ADDENDUM NO. 01

November 7, 2025

To Drawings and Specifications dated October 24, 2025

Reynolds Elementary School Maintenance Improvements
Spring Independent School District

PLUMBING PLANS - ENLARGED

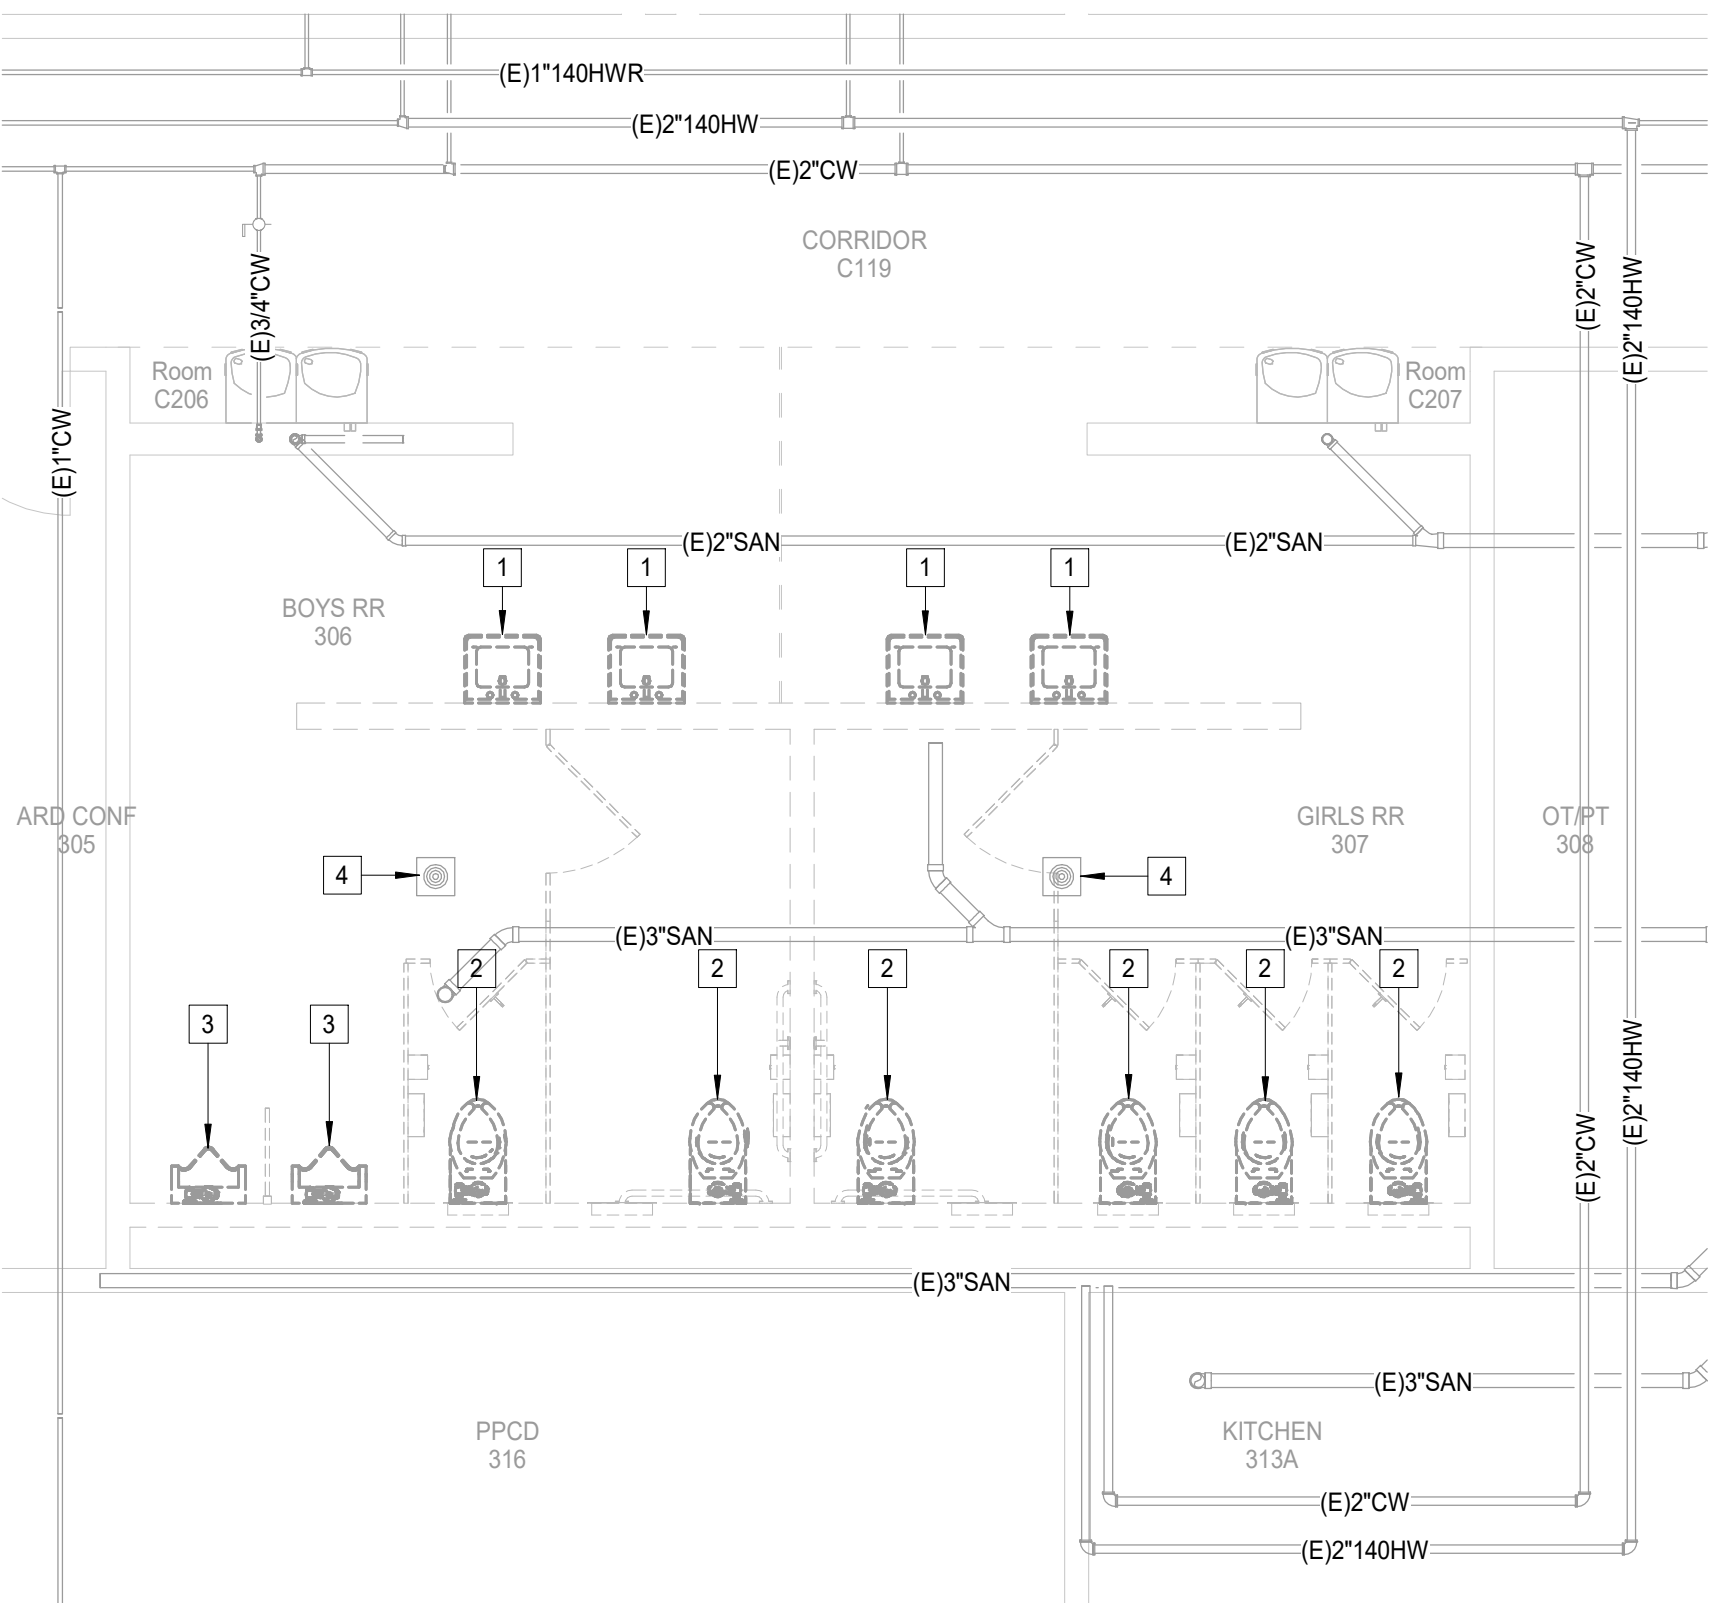
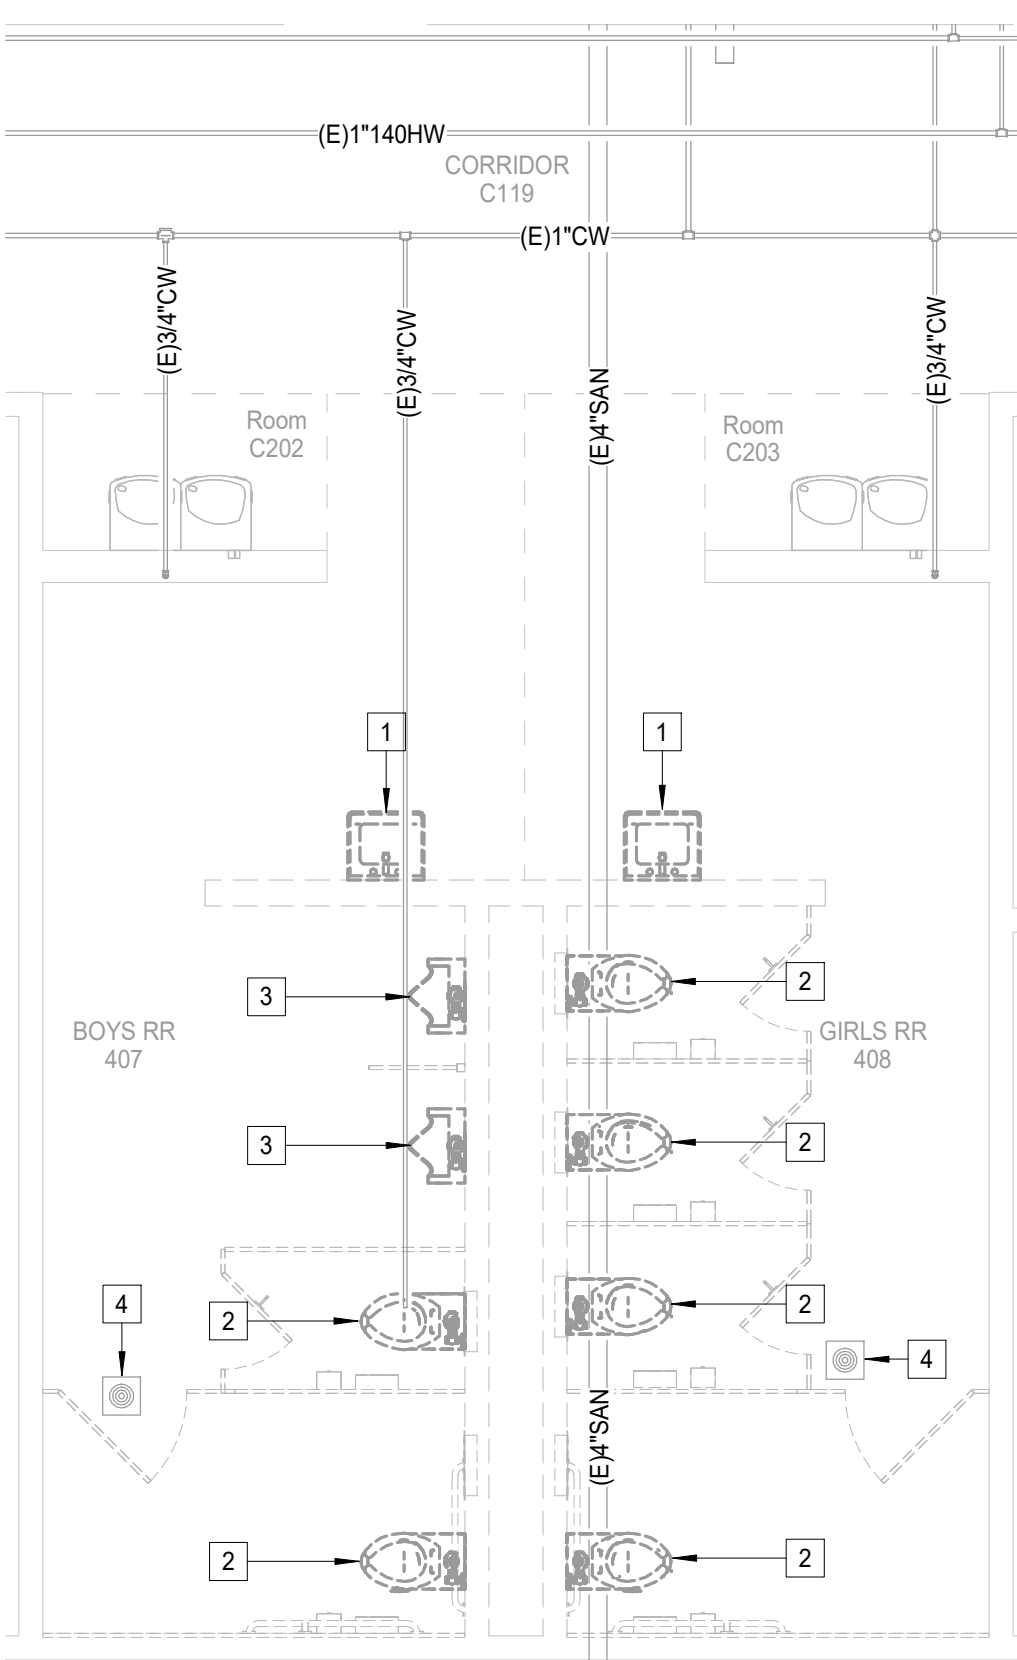
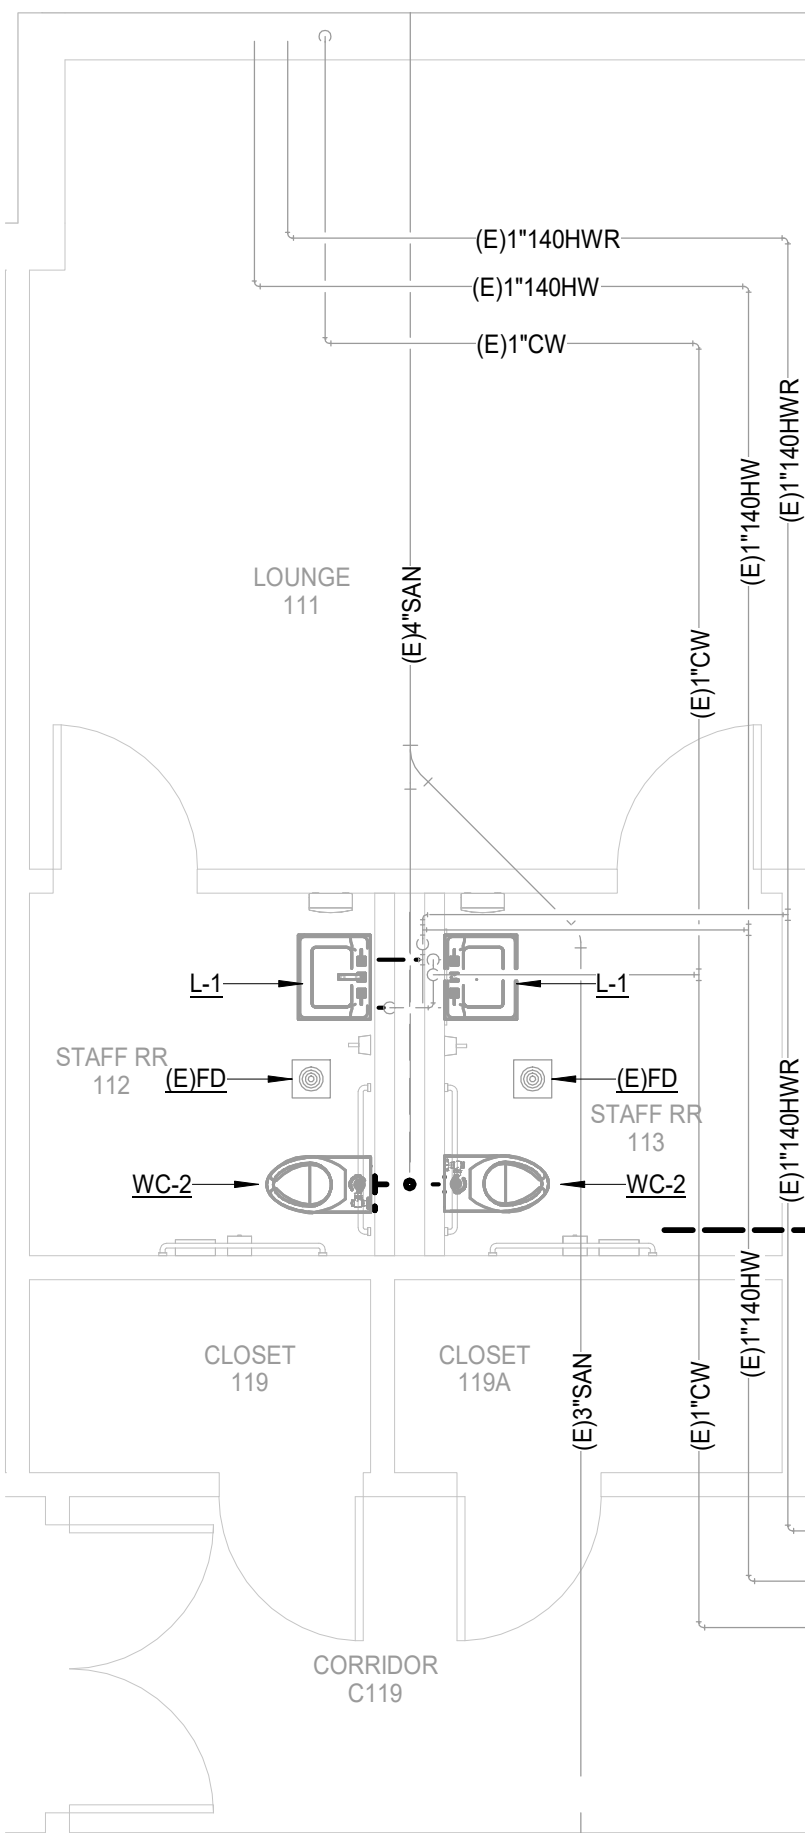
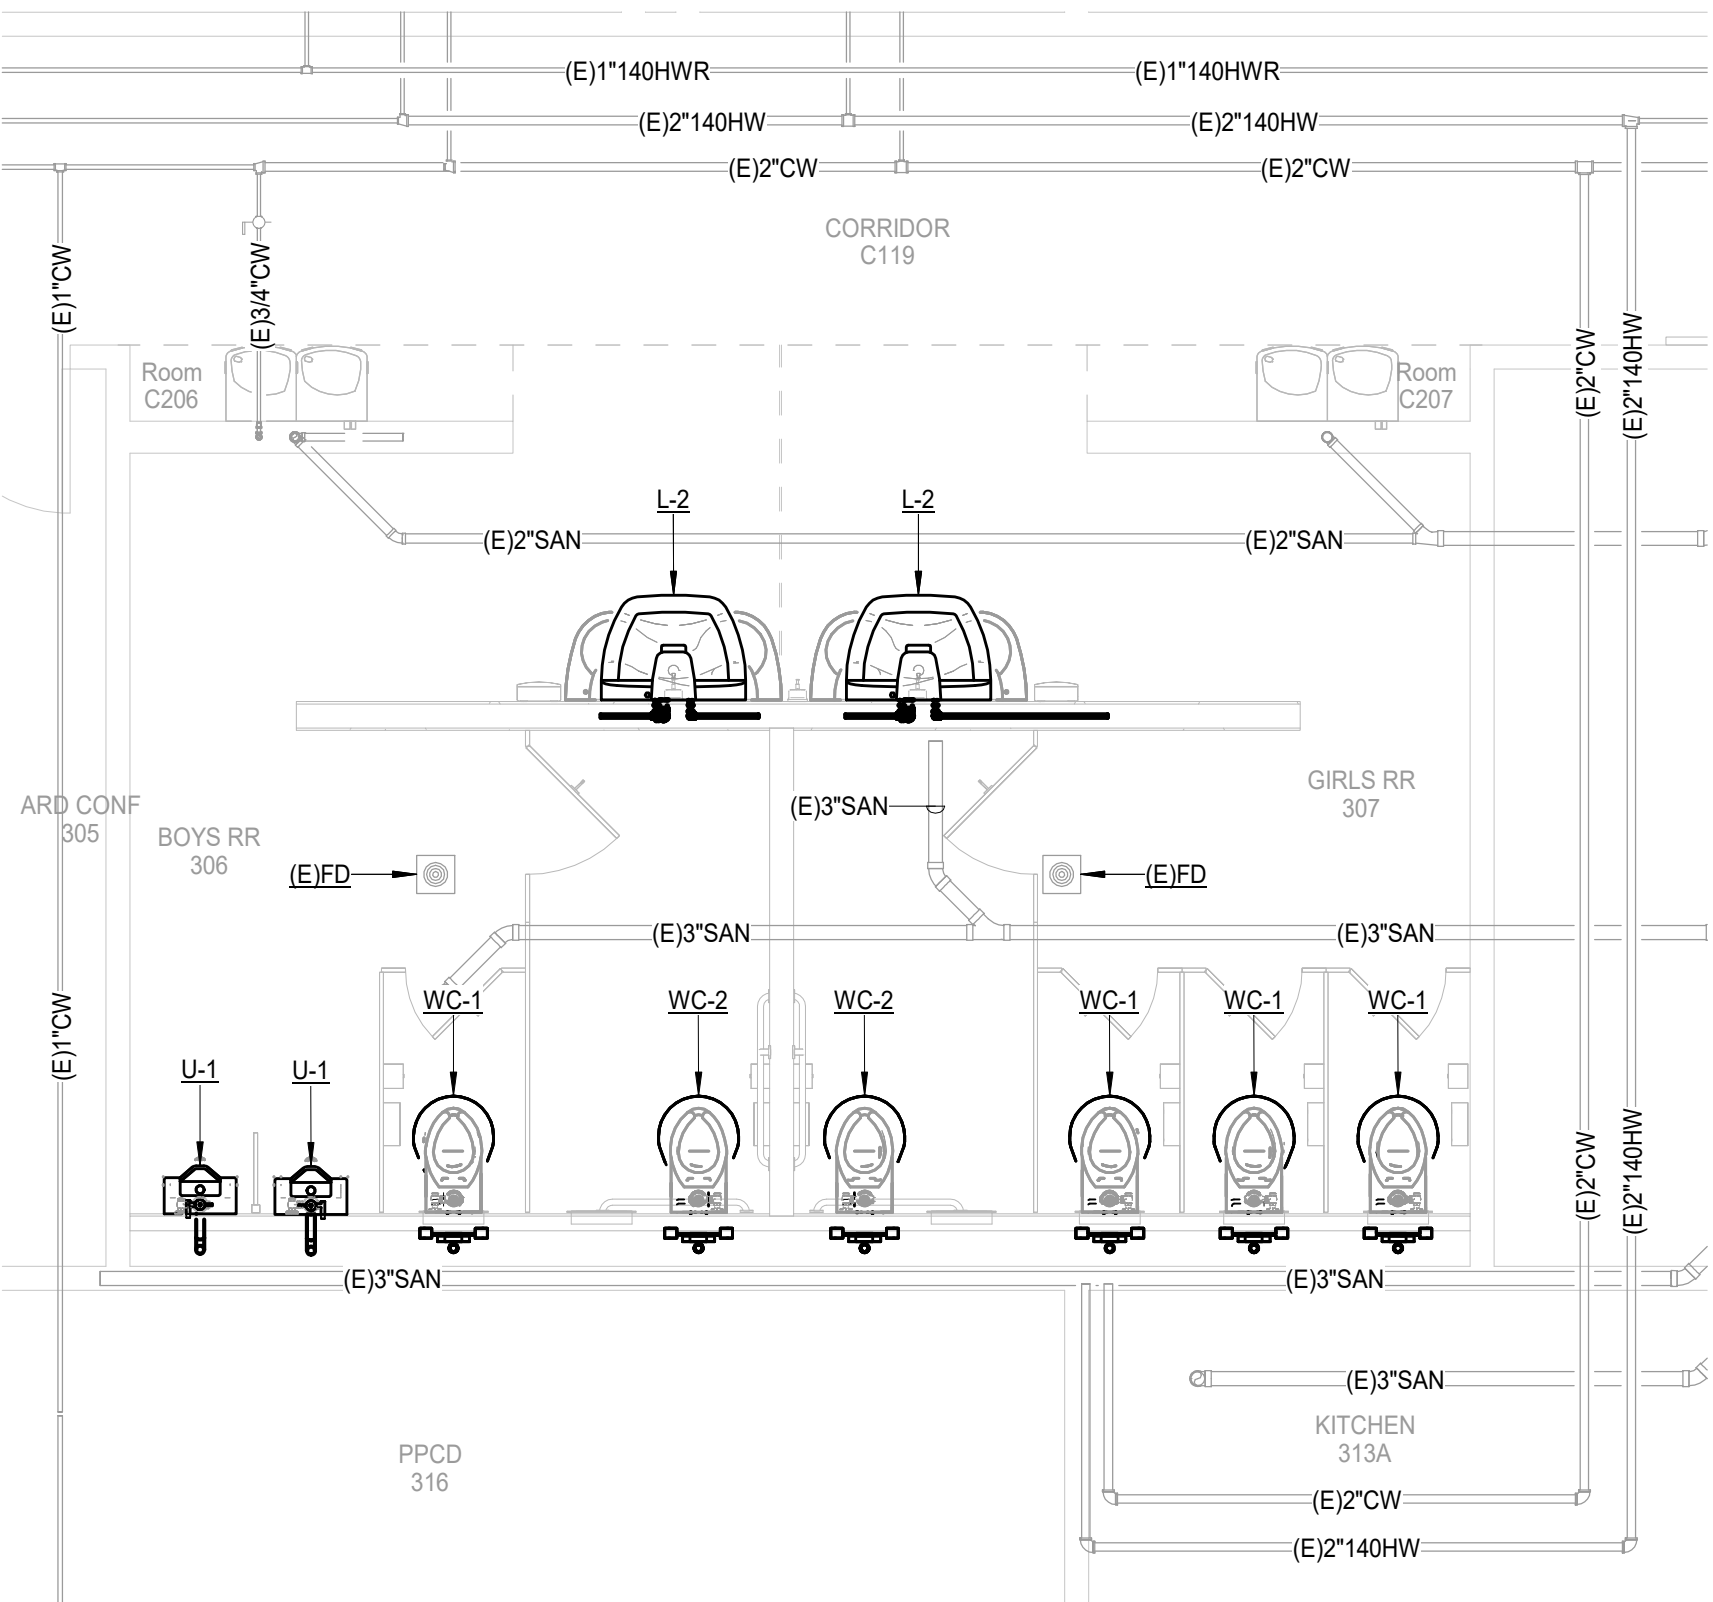
- Item No. 34 Sheet P-4.01, Plumbing Plans – Enlarged
B. Discard and replace with enclosed.
a. Revise Keynote #1 to state, “EXISTING LAVATORY FIXTURE AND CARRIER TO BE REMOVED. REMOVE CW, HW, SANITARY AND VENT BACK TO POINT INDICATED.”

b. Revise Keynote #2 to state, “EXISTING WATER CLOSET FIXTURE AND CARRIER TO BE REMOVED. REMOVE CW, SANITARY AND VENT BACK TO POINT INDICATED.”
c. Revise Keynote #3 to state, “EXISTING URINAL FIXTURE AND CARRIER TO BE REMOVED. REMOVE SANITARY, CW AND VENT BACK TO POINT INDICATED.”

- Item No. 35 Sheet P-4.01, Plumbing Plans – Enlarged
B. Discard and replace with enclosed.
a. Revise Keynote #1 to state, “EXISTING LAVATORY FIXTURE AND CARRIER TO BE REMOVED. REMOVE CW, HW, SANITARY AND VENT BACK TO POINT INDICATED.”

b. Revise Keynote #2 to state, “EXISTING WATER CLOSET FIXTURE AND CARRIER TO BE REMOVED. REMOVE CW, SANITARY AND VENT BACK TO POINT INDICATED.”
c. Revise Keynote #3 to state, “EXISTING URINAL FIXTURE AND CARRIER TO BE REMOVED. REMOVE SANITARY, CW AND VENT BACK TO POINT INDICATED.”

- Item No. 36 Sheet P-4.01, Plumbing Plans – Enlarged
A. Discard and replace with enclosed.
a. Revise Keynote #4 to state, “EXISTING LAVATORY FIXTURE AND CARRIER TO BE REMOVED. REMOVE CW, HW, SANITARY AND VENT BACK TO POINT INDICATED.”

b. Revise Keynote #5 to state, “EXISTING WATER CLOSET FIXTURE AND CARRIER TO BE REMOVED. REMOVE CW, SANITARY AND VENT BACK TO POINT INDICATED.”
- Item No. 37 Sheet P-6.01, Plumbing Schedules
